Range H&C	Model 9100	N° T.I. 06_2016
Serial Number 62214555	Subject SOLENOID ASSEMBLY WITH FITTING FOR Z4000 ES-FB	N° Case N/A

With the aim to strengthen our equipment, starting from S/N **62214555**, the **solenoid assembly with fitting**, marked with the **"A"** letter, replaces the **"B"** one (see pictures below).

Solution A
Solenoid assembly with fitting
 Spare code: **260051**

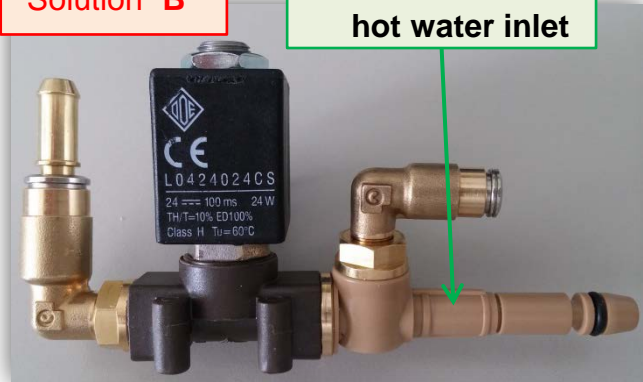
Solution B
Solenoid assembly with fitting
 Spare code: **260053**

Note: the **hot water inlet** and the **solenoid valve** are fixed with liquid sealing (**Loctite 5331**).
See next page: "Instructions to switch from "B" to "A" solution".

2. Remove

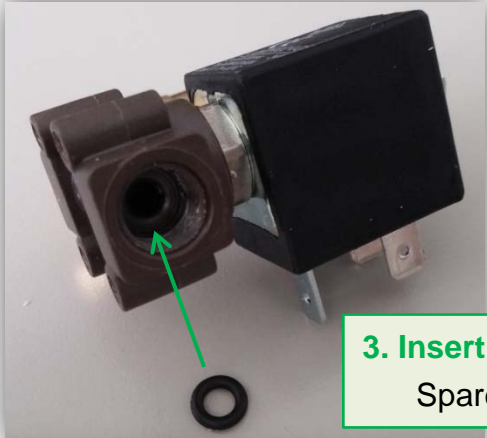
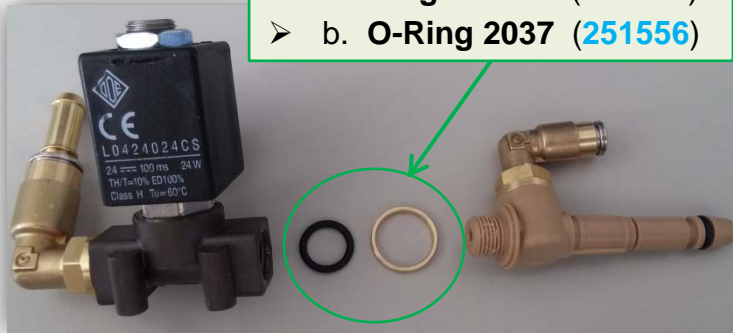
1. Unscrew the hot water inlet

- a. Ring for O-R (**260054**)
- b. O-Ring 2037 (**251556**)

4. Put the liquid sealing "Loctite 5331" on the two threaded surfaces

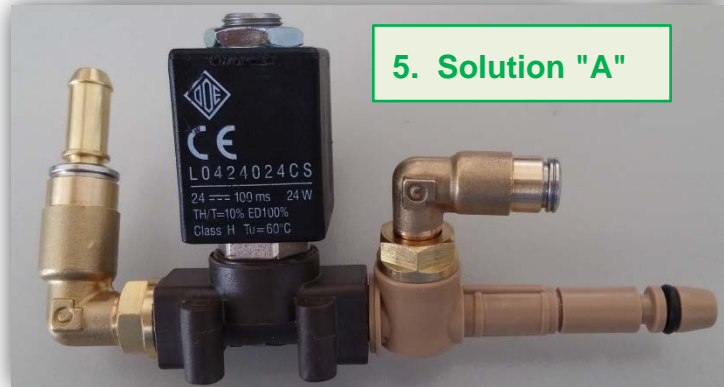
5. Solution "A"

- Properly **tighten** the *hot water inlet* to the *solenoid valve*.
- **It's required to wait 24 hours** before using the solenoid assembly (A)
